IN THE MATTER OF:)
)
AMEREN ASH POND CLOSURE RULES) R09-21
(HUTSONVILLE POWER STATION) :) (Rulemaking – Land)
PROPOSED 35 ILL. ADM. CODE 840.101)
THROUGH 840.144)

AGENCY’S RESPONSE CONCERNING BOARD’S ORDER OF JANUARY 7, 2010

ATTACHMENT 3

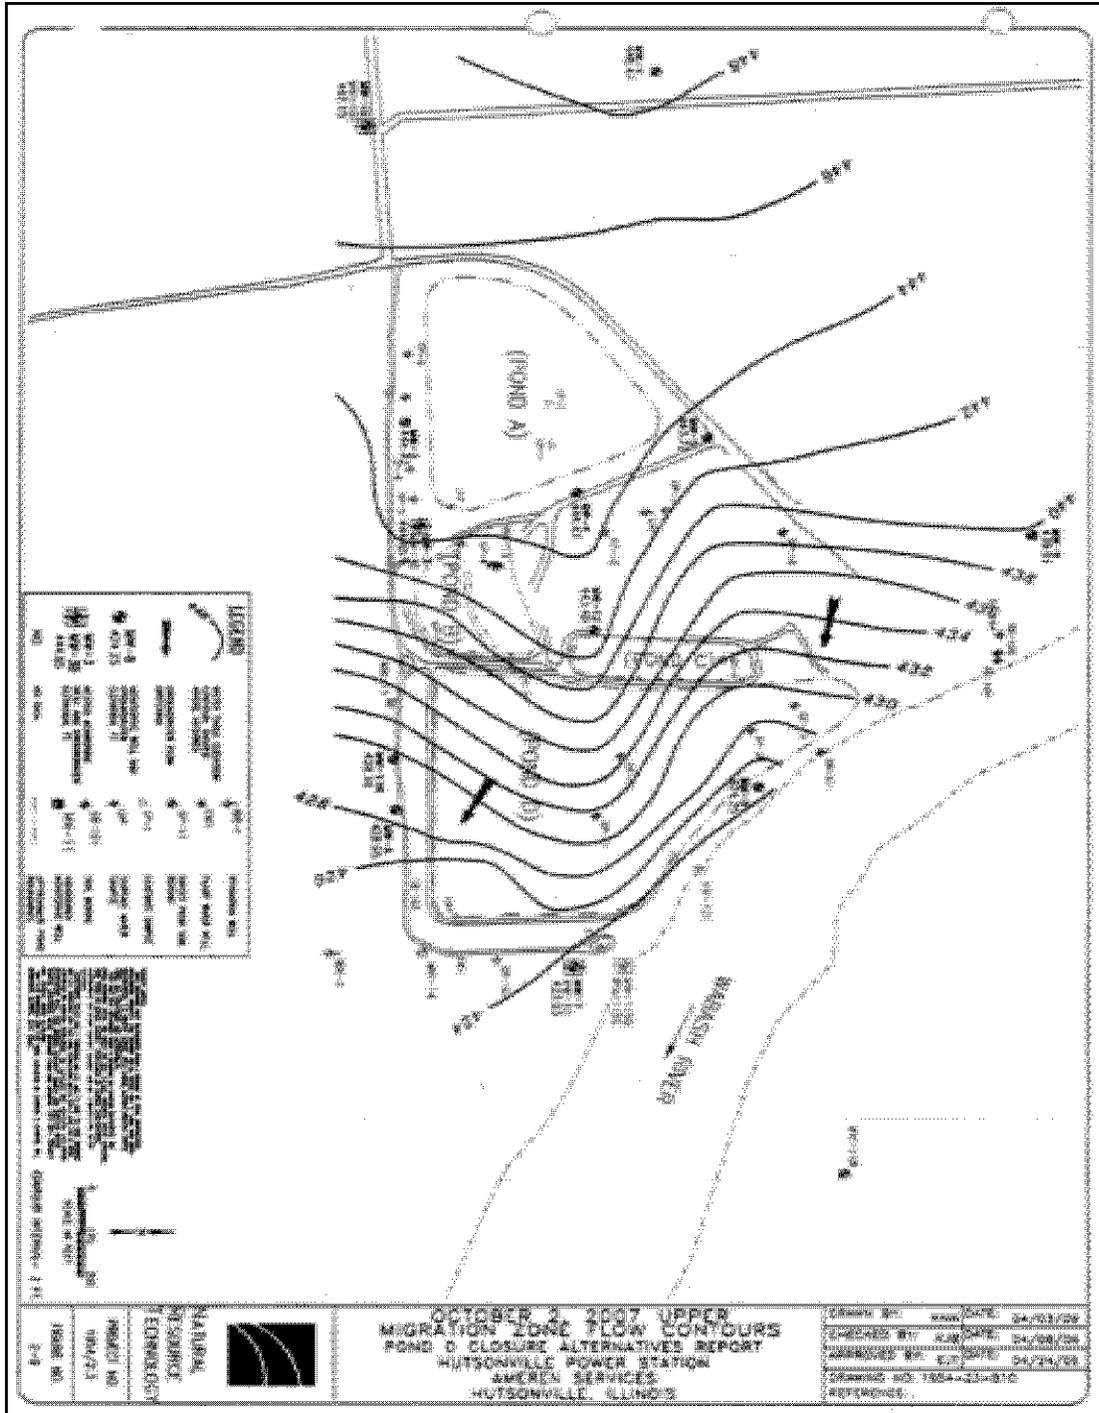
The map at Attachment 3 shows that Ash Pond D, which is recharging the water table of the upper zone of the aquifer, is now up-gradient of MW-14 and IRR-1 and is in a position to recharge the LAI and ZOC of IRR-1 in the lower zone of the aquifer. The map also shows the location of MW-14. MW-14 is screened in the coarse-grained lower zone of the aquifer, is down-gradient of Ash Pond D during the transient condition just described, and more importantly for the Board's concerns, it is up-gradient from the influence of IRR-1, the closest irrigation well. Attachment 3; TSD at 40.

ATTACHMENT 4

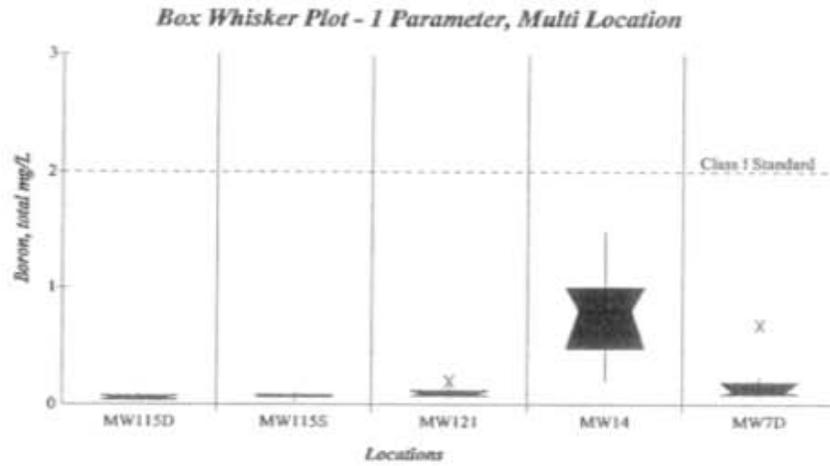
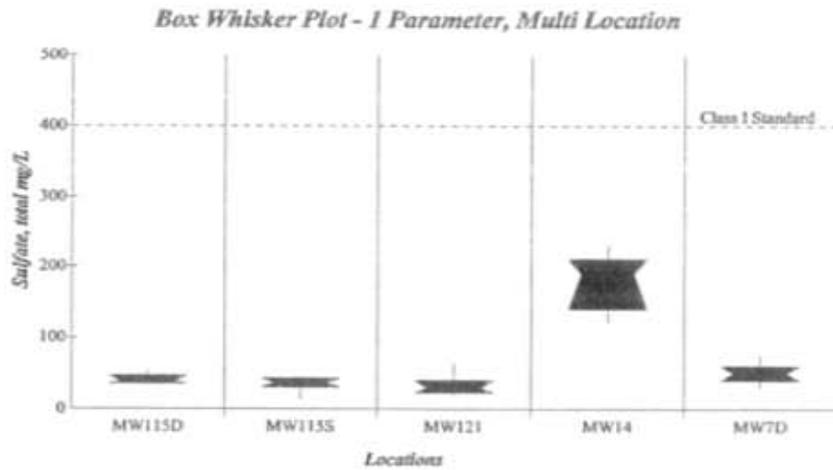
Box plots are even more useful in comparing these attributes among several data sets or, in this case, the different monitoring wells at the Hutsonville site. The box plot shows the concentrations occurring between 90, 75, and 25 percent of the time. Attachment 4 shows that the boron concentration (most mobile contaminant of concern) in MW-14 is at a concentration of less than or equal to 1.6 mg/L ninety percent of the time. More importantly, the greatest paucity of the data shows boron to be at a concentration of less than 0.8 mg/L. Statistically, this means that concentrations of 0.8 mg/L are more likely than 1.6 mg/L at this location. In addition, Mr. Cobb testified in a follow-up answer to a question from Ms. Barkley of PRN to Mr. Bollinger of Ameren questioning the accuracy of the depicted data sets:

Testimony of Mr. Cobb, TR. at 53 - 54. Therefore, the Agency has concluded (based on the statistically accurate data in the TSD) the worst-case scenario for modeling contaminant transport would start with a concentration of 1.6 mg/L of boron. However, a more statistically accurate and representative starting place would be a concentration of 0.8 mg/L of boron.

ATTACHMENT 6

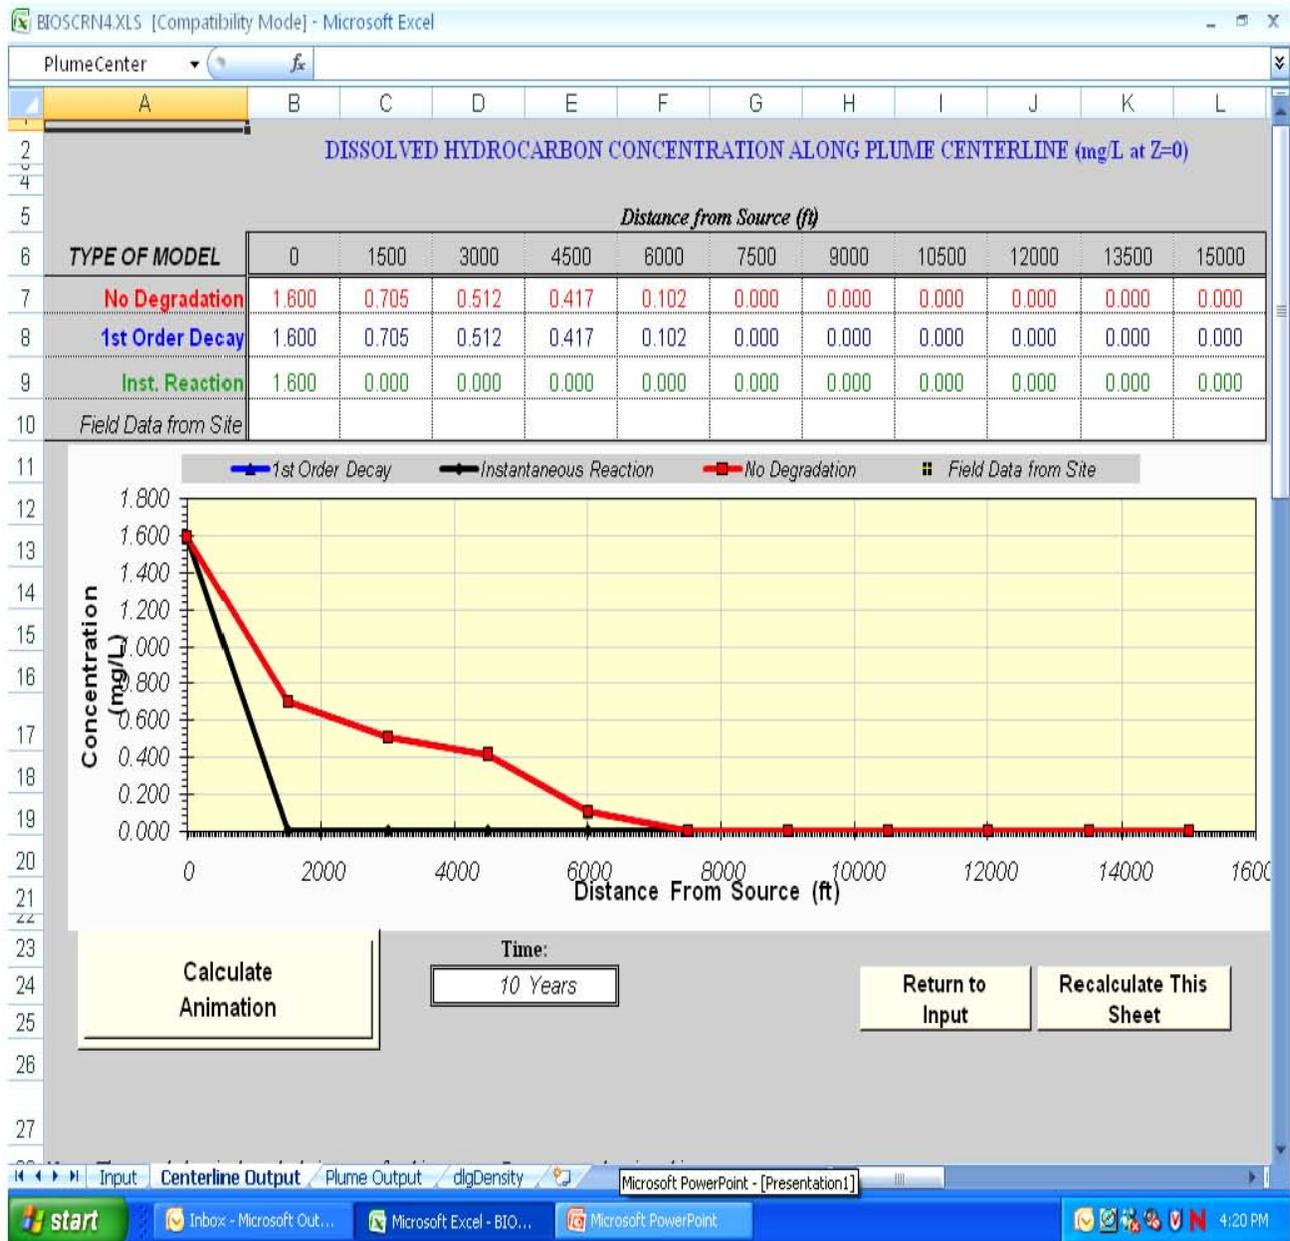
Attachment 5 provides a screen shot of the model input. Attachment 6 is another screen shot illustrating a graph of how dispersion is predicted to reduce the peak concentration of boron along the center line of the boron plume in the ZOC and LAI of IRR-1 or any other off-site irrigation wells, given the assumptions used. As described in Section I(B)(2) above, the greatest paucity of the data is at a concentration of 0.8 mg/L, so it would be very reasonable to slide both graph lines to the left until they intersect with 0.8 mg/L on the y axis of the graph. Attachment 7 is a screen shot predicting the effects of dispersion on the boron plume in the X, Y, and Z directions, given the assumptions used. In each case, the screen shots show that concentrations will drop off rapidly from the concentration assumed at MW-14.

Even in the worst case scenario – starting concentration at MW-14 of 1.6 mg/L of boron, steady state conditions, and a constant source of contamination -- the modeling predicts that over a ten year period the concentrations of boron from Ash Pond D in the lower zone of the underlying aquifer will diminish from 1.6 mg/L at MW-14 as the groundwater intermittently migrates down-gradient from MW-14 toward IRR-1. In no case will concentrations equal or exceed the numeric groundwater quality standard for boron of 2.0 mg/L, which is based on irrigation as discussed in Section I(B)(5) immediately below. Moreover, based on the same
